Eastern Area Planning Committee

2nd December 2021

7a) PL/2021/06348 Rabley House, Poulton, Nr. Marlborough, SN8 2LW

Retrospective installation of stable windows and external door to tack room to existing barn and external lighting

South West Elevation 1100

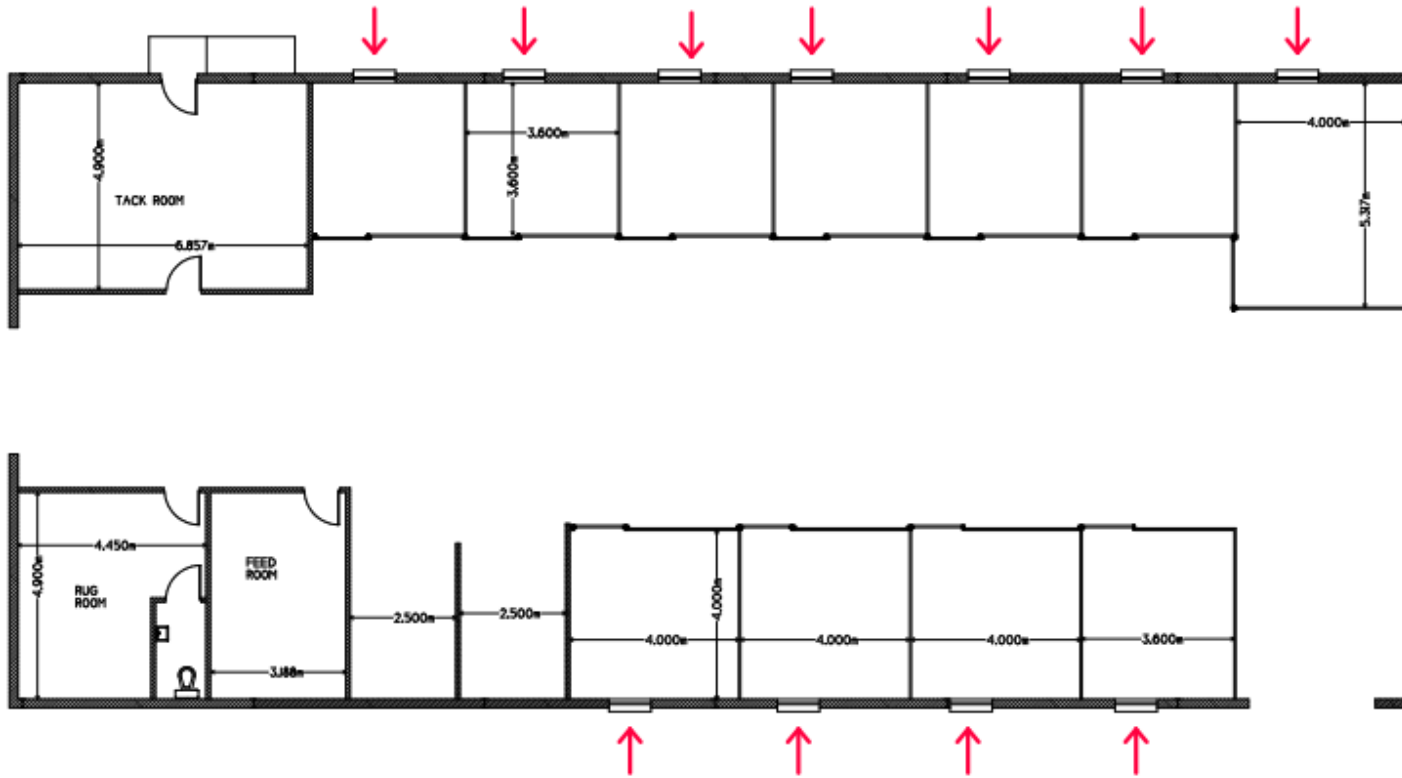
- this attractive diagram of the SW view is overtly misleading
- There is no cladding and no ability to enforce its application
- It omits the row of blocks removed under the eaves - added in blue – equivalent to a 30m strip light
- It omits the wiring boxes in place for further lighting

Submitted Block Plan

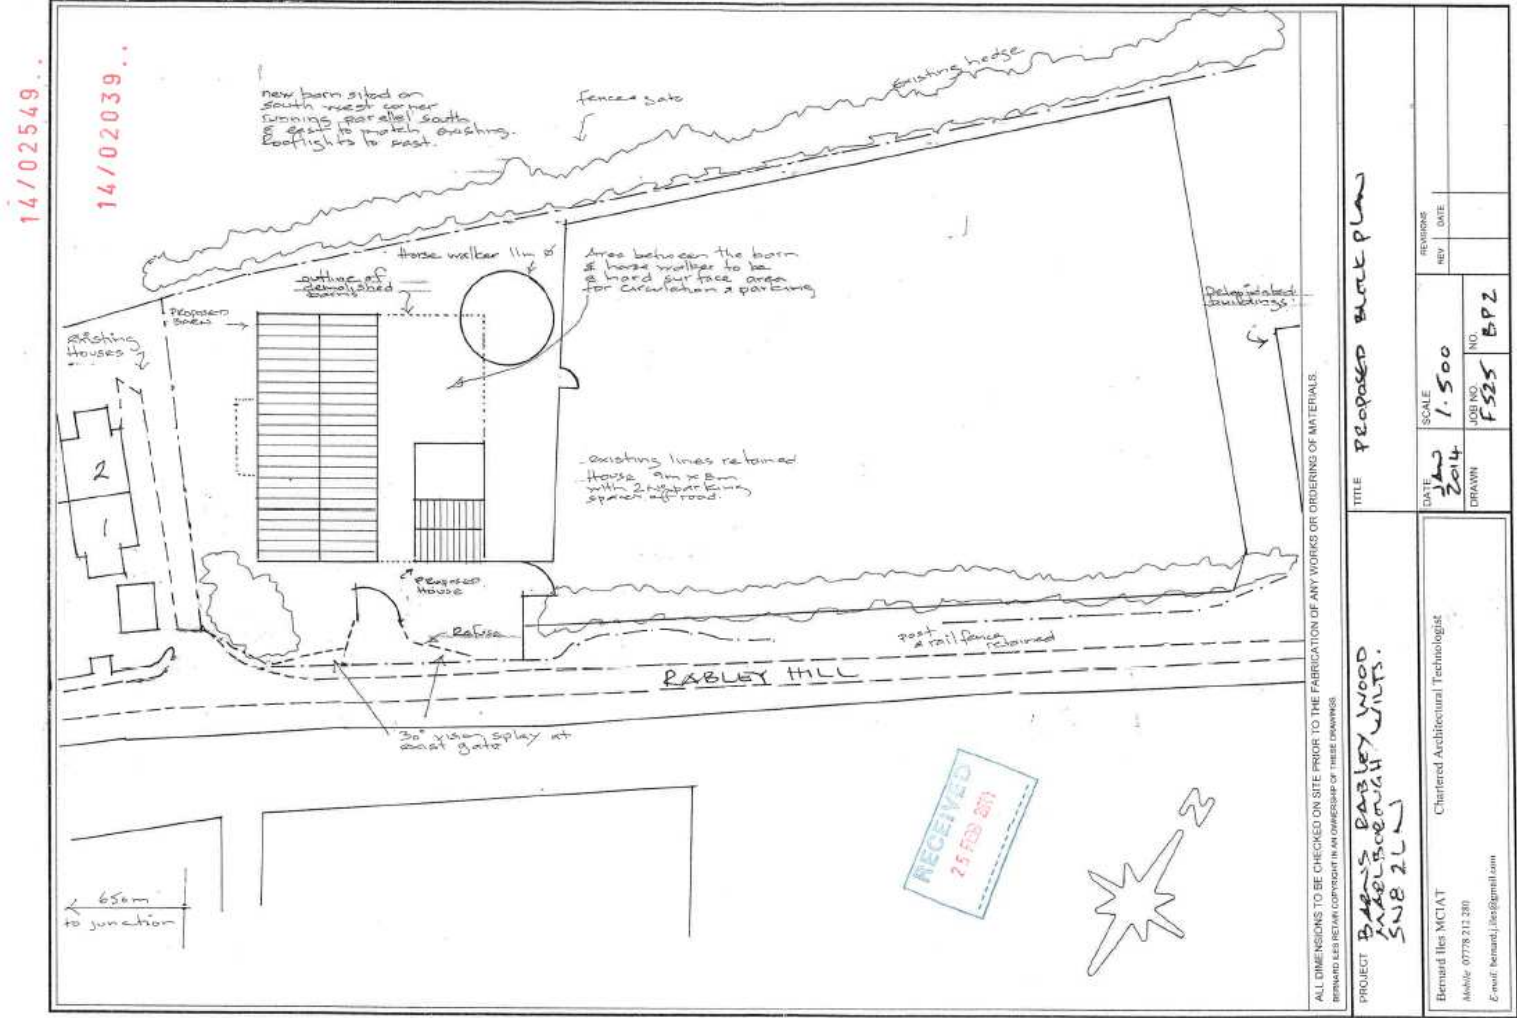
Clearly implying intent to retain trees and location of lorry parking. But trees were removed before the condition discharge.

What conclusion can be drawn?
 Removal of trees to give access to actually intended parking...avoiding harm to their property?

Huge Light Spill

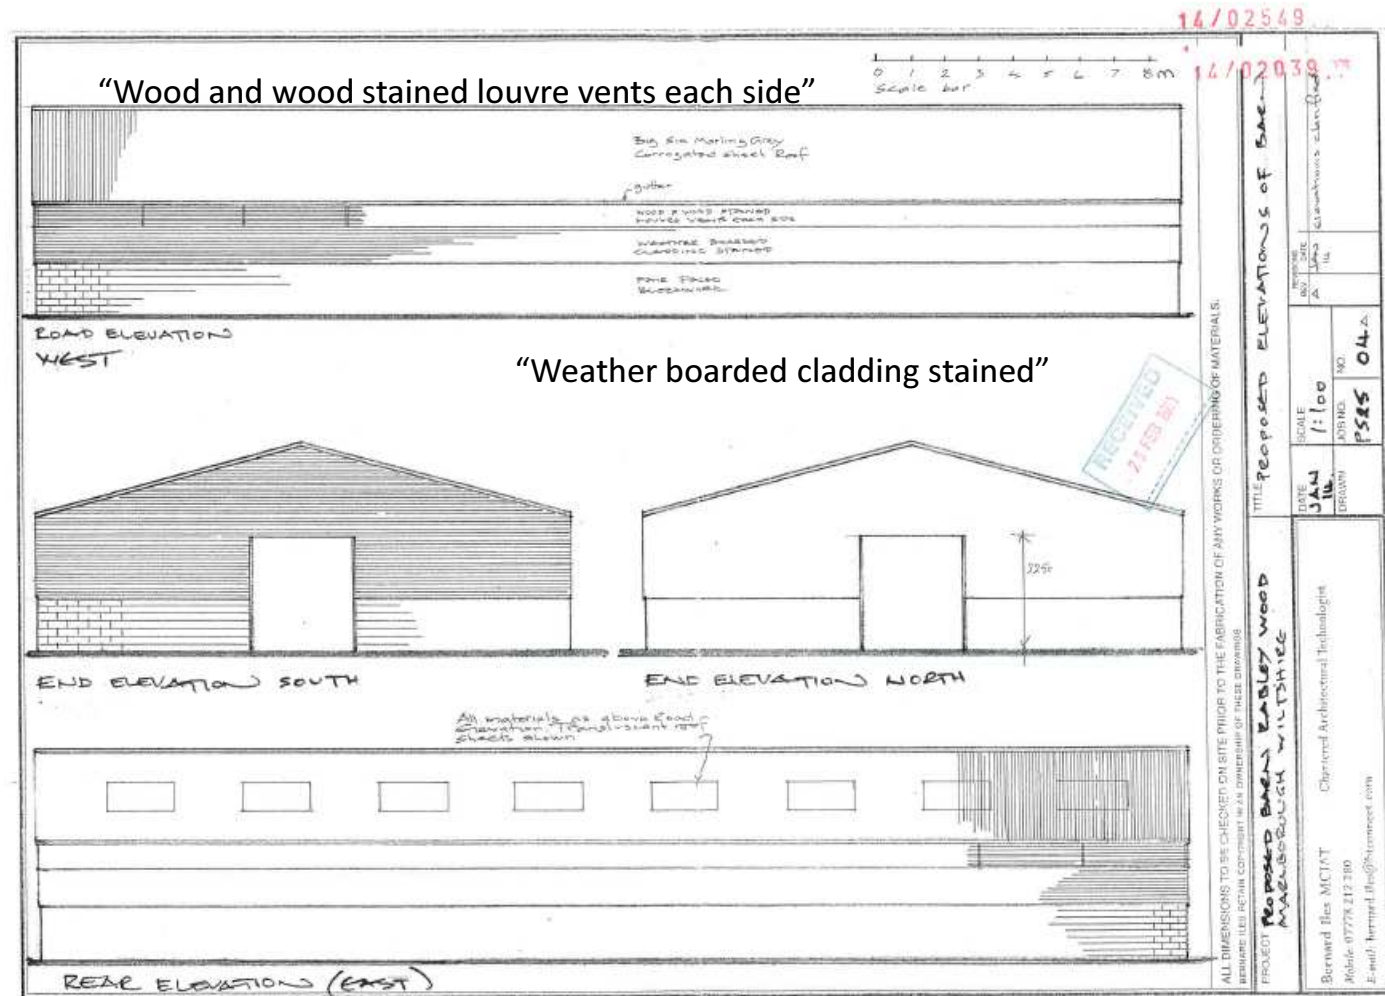
Even with 3m+ high lorries in the way.

“...although the openings allow more light from the internal lighting to spill out, the level is not considered to be significant enough to warrant the refusal of planning permission”

How much significant enough?
